M-2004-051 Technical Revision 04 - Wattenberg Lakes Mine

RE: Wattenberg Lakes Aggregate Mining Design Modifications, Weld County, Colorado; U.S Army Corps of Engineers (Corps) File No. NWO-2000-80189-DEN

Wattenberg Lakes Gravel Mining Revised Compensatory Mitigation Plan Weld County, Colorado

SPILLWAY PLAN AND PROFILE

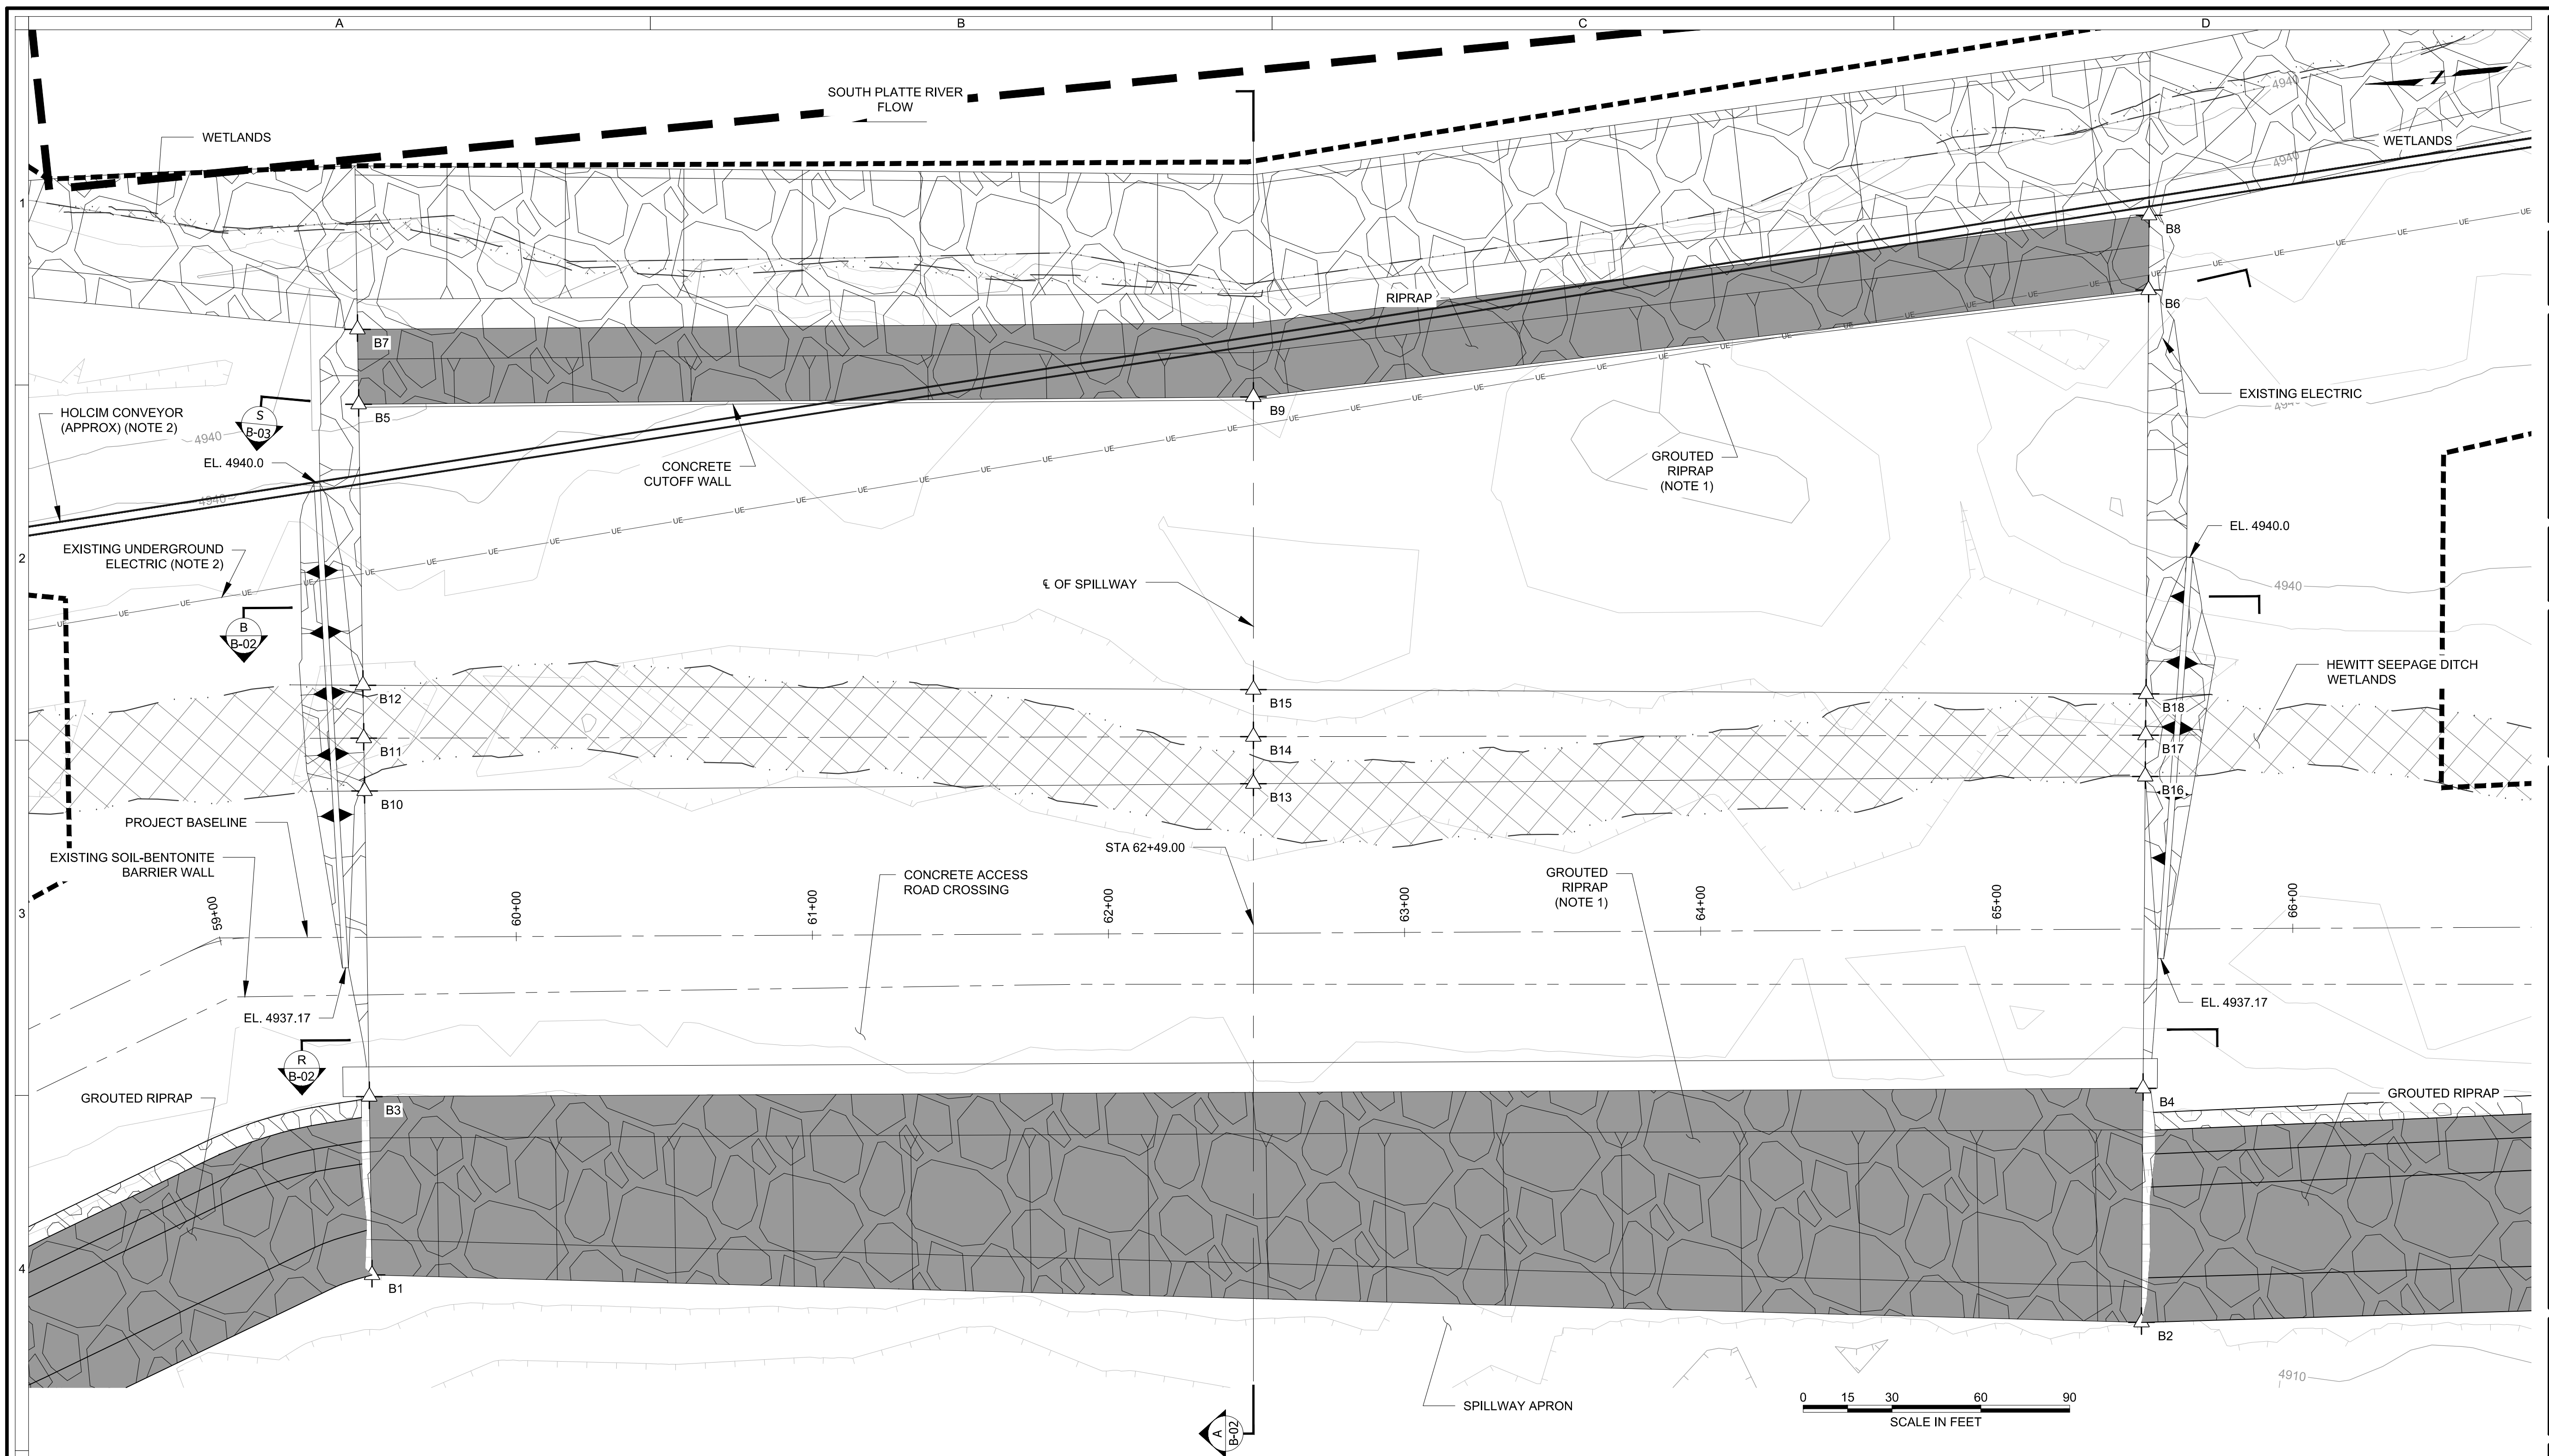
The spillway would consist of armored slope protection on the bank along the South Platte River and for a stretch along the east side of the reservoir to allow flood flows in the river to safely enter and exit the reservoir without eroding the banks of the South Platte River or the reservoir (Figure 3; Appendix A). The spillway would be approximately 600 feet long at the crest and a concrete cutoff wall would be constructed near the crest on the South Platte River side and would extend about 4-feet deep and be 5-feet wide. The spillway chute along the east bank of Pond 3 would consist of a 2-foot layer of grouted

riprap over 9-inches of drain material. The top of the spillway would primarily be earthen, with the Huett Ditch incorporated as part of the spillway to continue to support wetlands and flows through the spillway and to the north (downstream). A 10-foot-wide concrete road would be constructed along the top of the spillway for access. To be in compliance with the decreed flow allowances, water that enters the reservoir through the spillway during flood events could be discharged back to the river via the spillway (at high reservoir elevations), or via the previously permitted pump station outlet.

Figure 3. Proposed Design Modifications

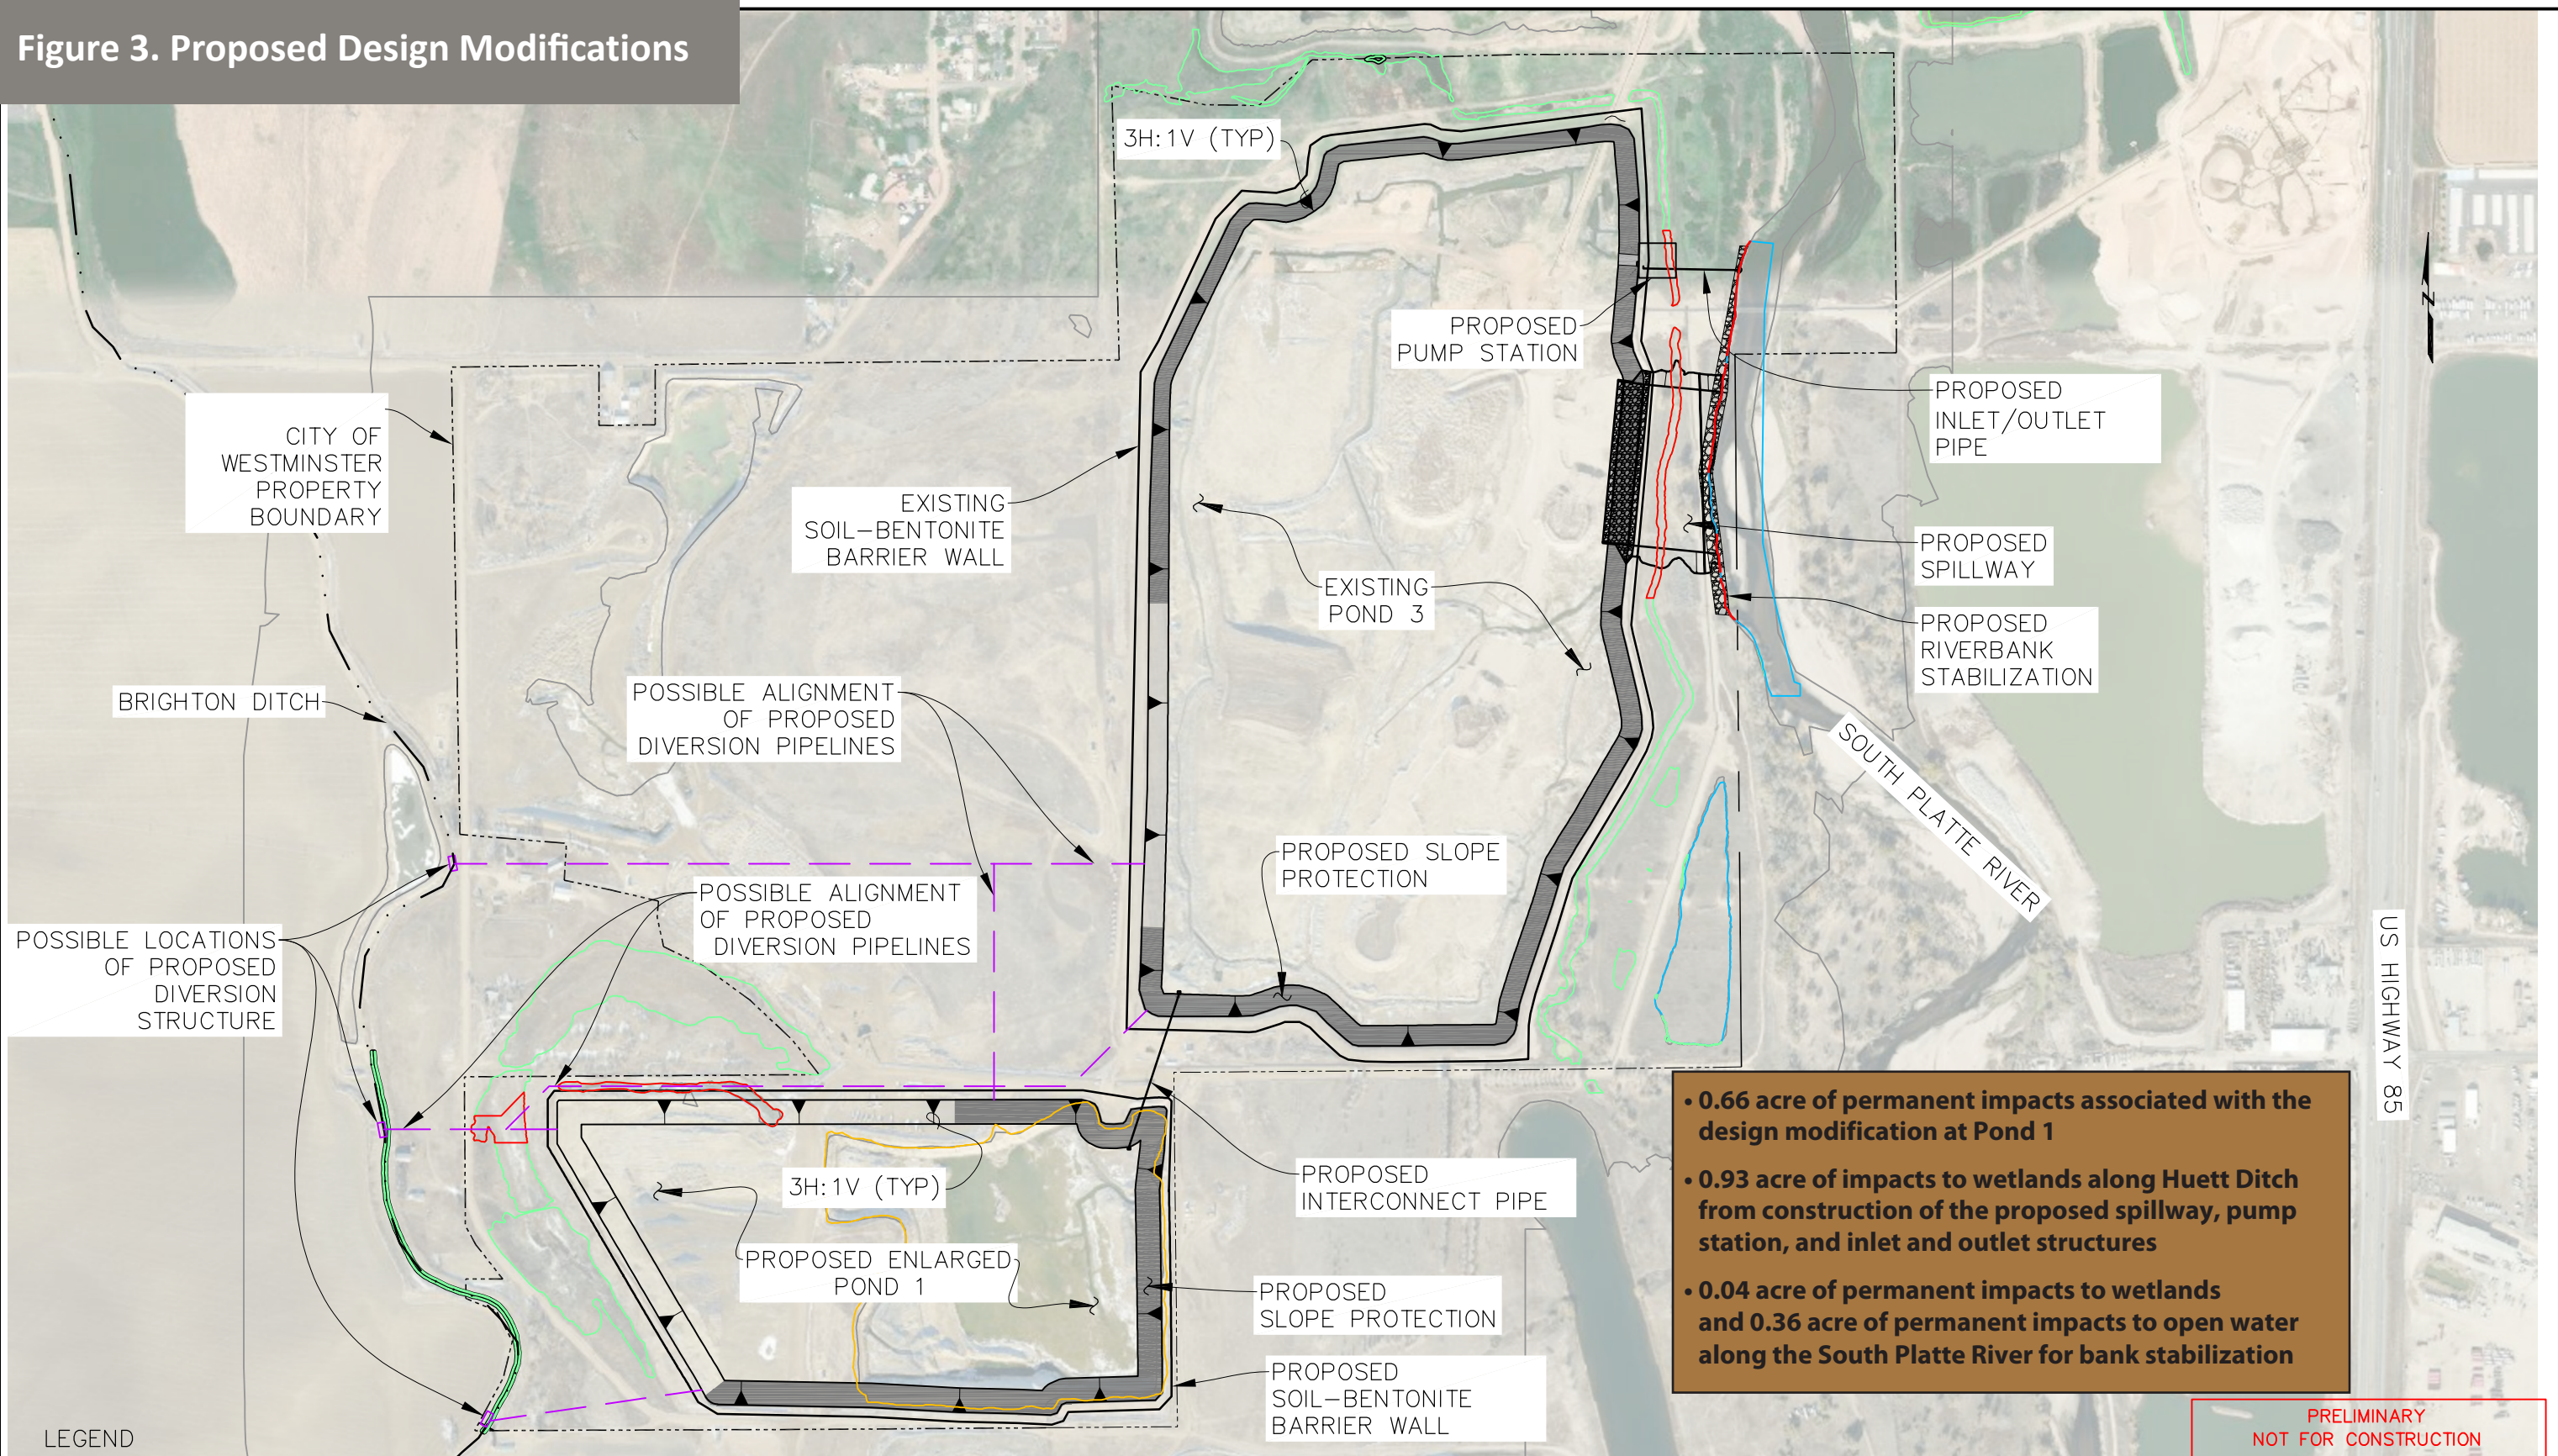
The impacts from mining activities and reservoir construction were largely to the Huett Ditch and Lupton Slough. Onsite mitigation originally and currently proposed are focused on recreating the form and function of the ditch and slough. Mitigation associated with Huett Ditch has already occurred and focused on recreating the form and function of the ditch and slough, resulting in the successful reestablishment of 2.34 acres in a wetland channel with varied flow, gradual banks, and native vegetation. The Huett Ditch would be incorporated along the crest of the spillway to continue to support wetlands and flows through the spillway and to the north (downstream). At the spillway, the previously established wetlands associated with Huett Ditch would be temporarily impacted during construction (Figure 3).
